July 24, 2024

Subject: Dairyland Power Cooperative – Alma Off-Site Disposal Facility Phase IV Landfill
Plan of Operation Modification for Initial Permitting of Coal Combustion Residuals (CCR)
Landfills – Addendum 2, Town of Belvidere, Buffalo County, Wisconsin
(License #4126)

Subject: Incompleteness Determination for the Plan of Operation Approval Modification for Initial Permitting of Coal Combustion Residuals (CCR) Landfill for the Dairyland Power Cooperative Alma Off-Site Disposal Facility, Phase IV Landfill (License #4126)

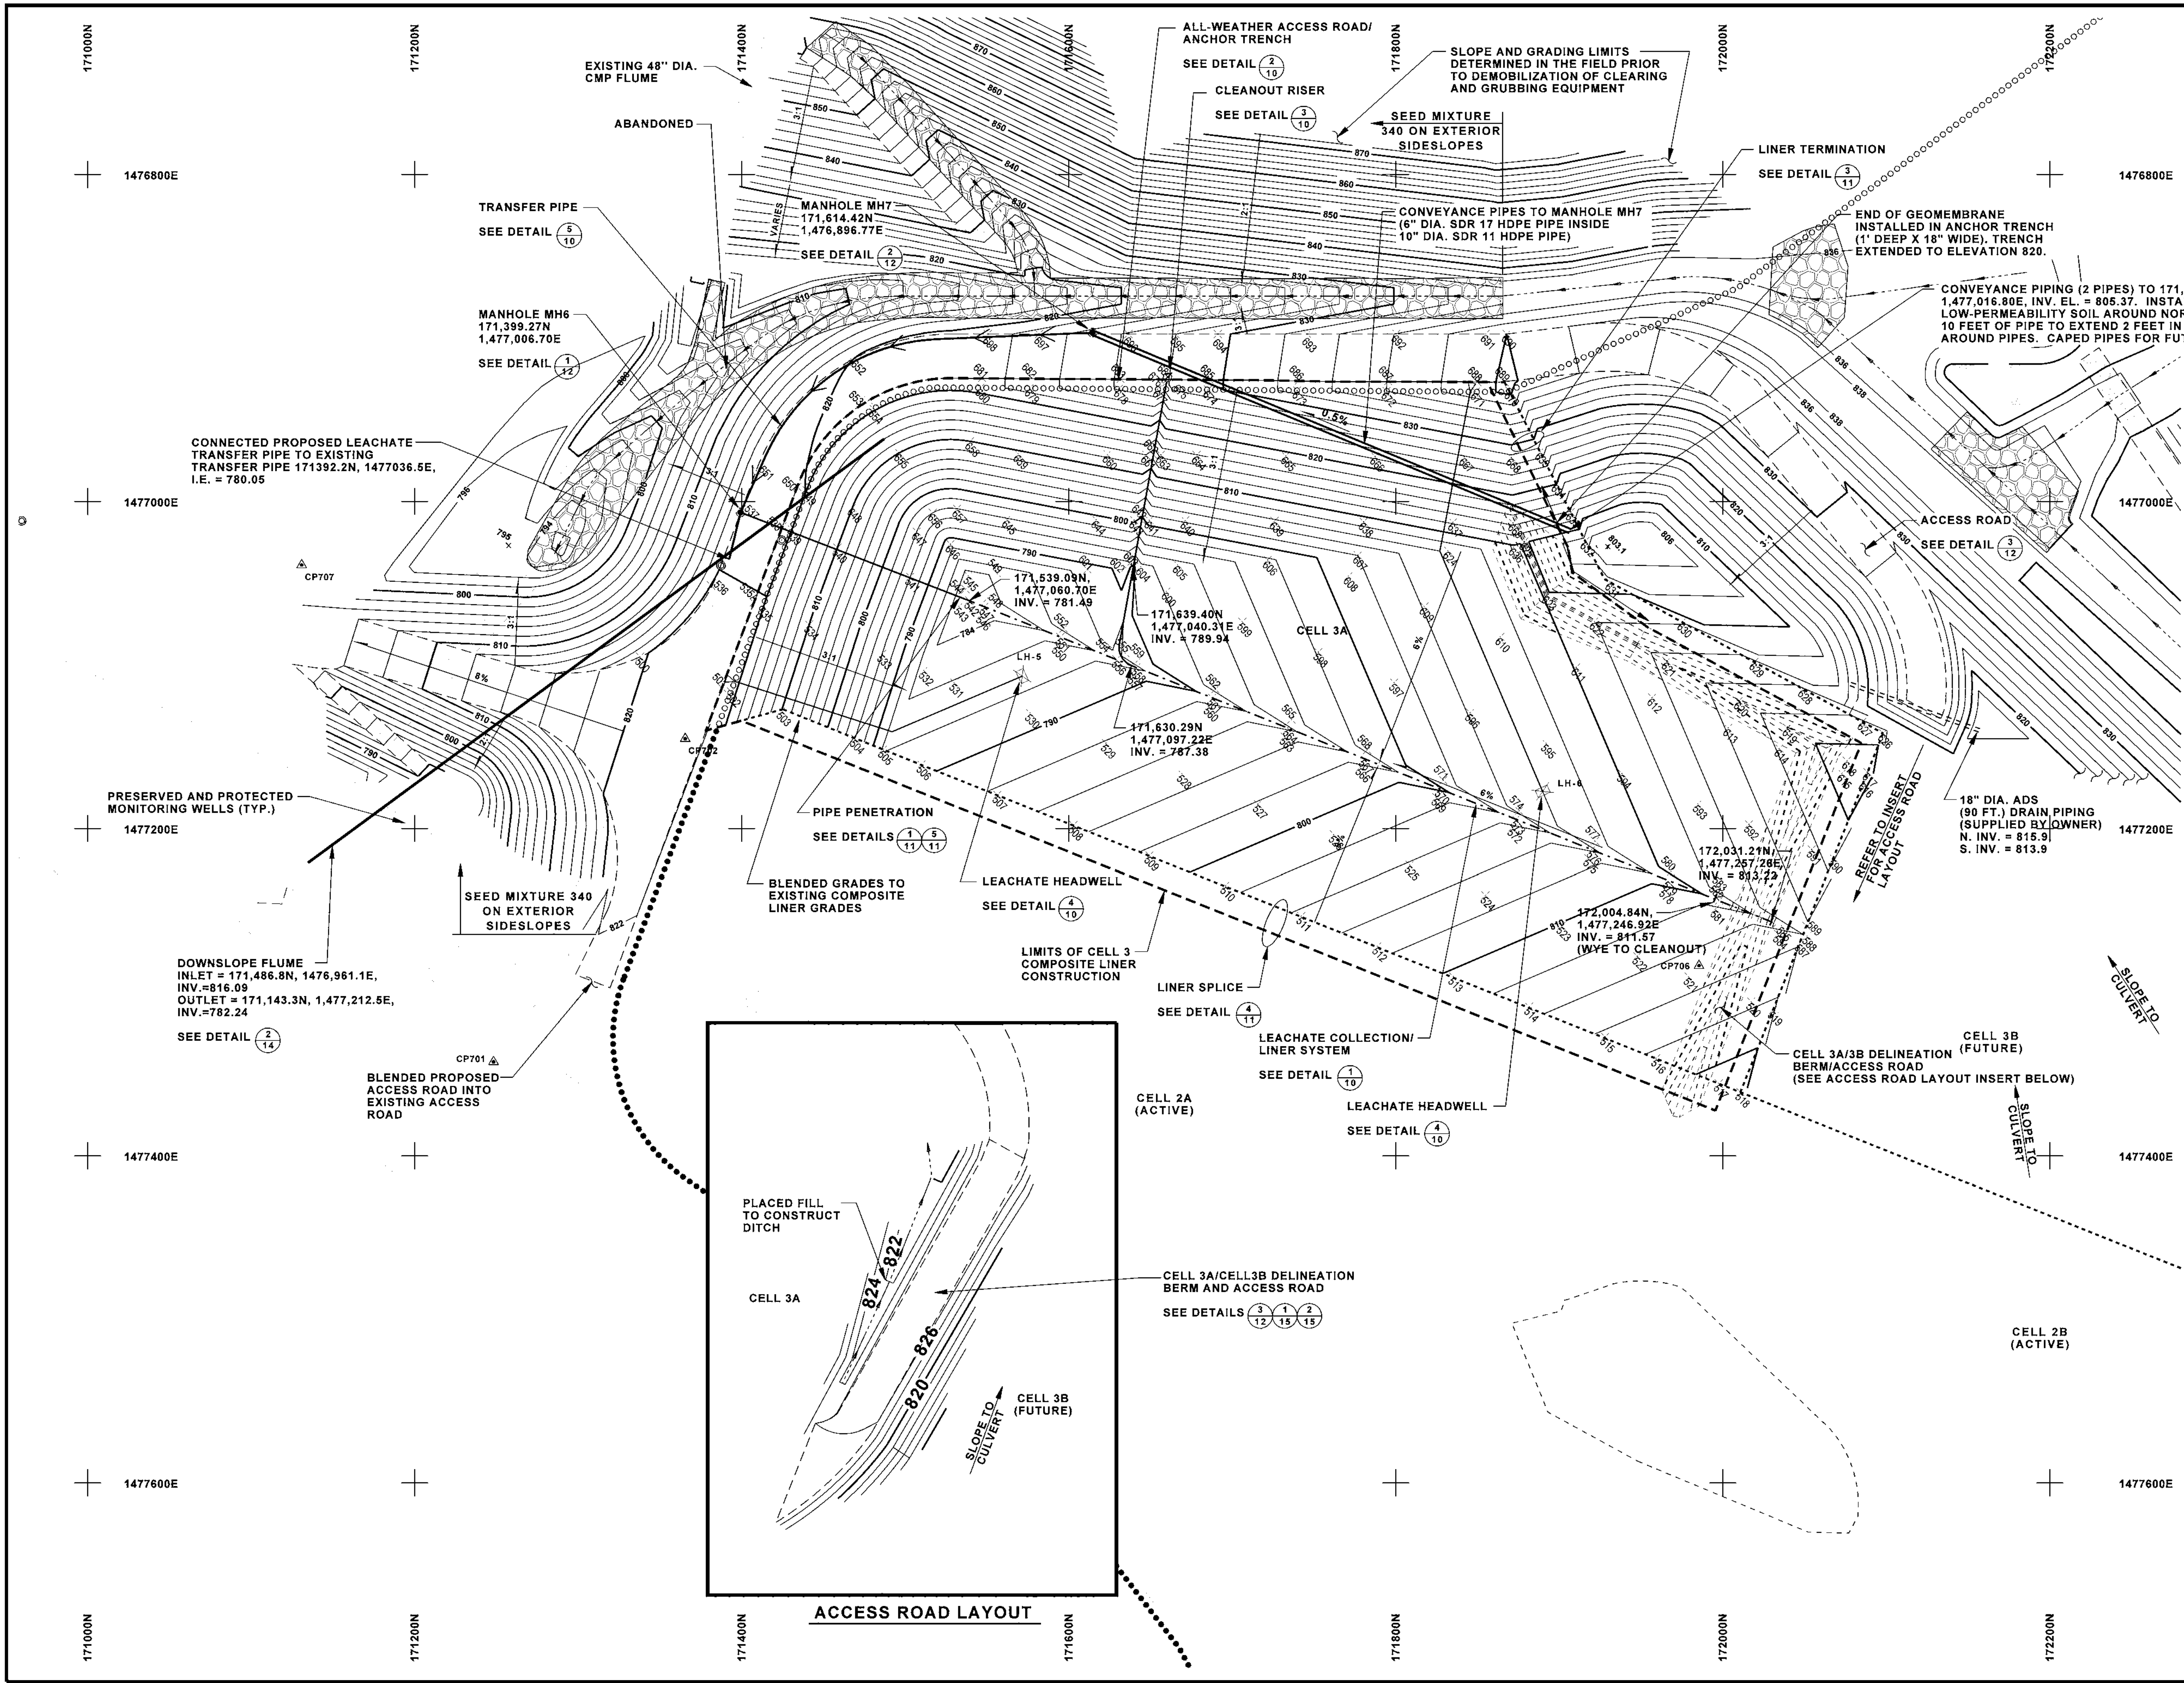
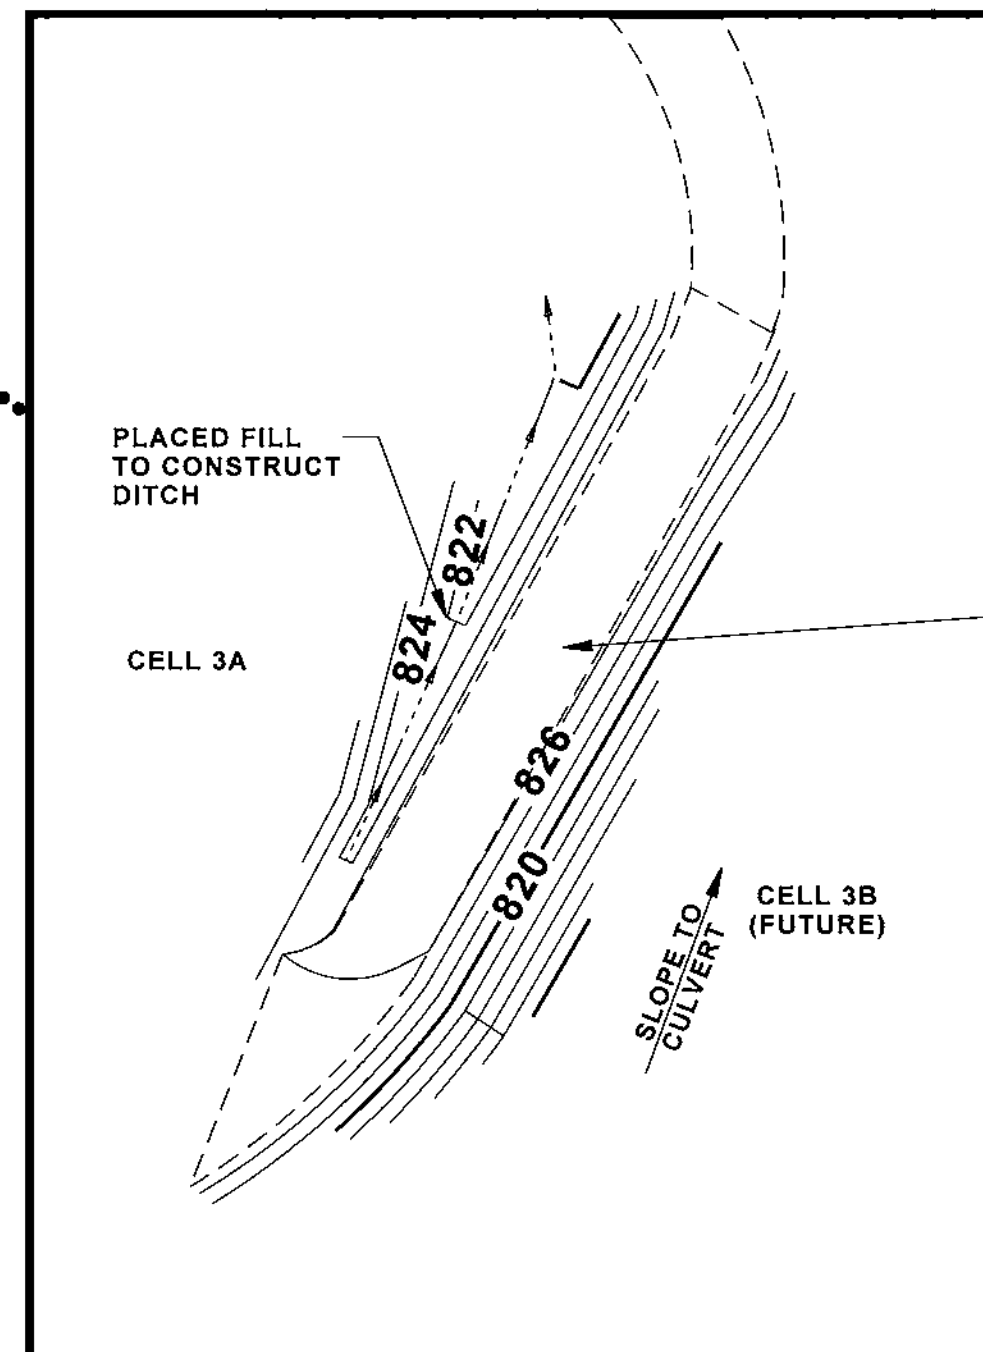
1. ***Section NR 504.04(5)(j), Wis. Adm Code: Provide a revised leachate removal system for Cell 4 which includes a sump and side slope riser design.***

1. **Section NR 504.06(5)(j), Wis. Adm. Code:** Provide a revised leachate removal system for Cell 4 which includes a sump and side slope riser design.

Because the non-perforated piping associated with Cell 4, Module A and B is routed within a portion of the Cell 3 build-out, a portion of Cell 4, Module A's gravity conveyance system was installed during liner construction of Cell 3A in 2012. This installed infrastructure consists of manhole MH7 along with the dual encased piping located between manholes MH6 and MH7, and two lines of piping from future Cells 4A and 4B to manhole MH7. Select low permeability soil (soil barrier layer) was placed around the northern 10 feet of the pipes and extended 2 feet in all directions. The installed pipes were capped for the future connections to occur during the construction of Cell 4A. Therefore, the only connections that need to occur are the connections that will occur at the liner penetration and within the limits of waste for the Cell 4A and 4B leachate collection piping if no changes are made to the design. The installed infrastructure is shown on Sheet 6 in **Attachment 3**.
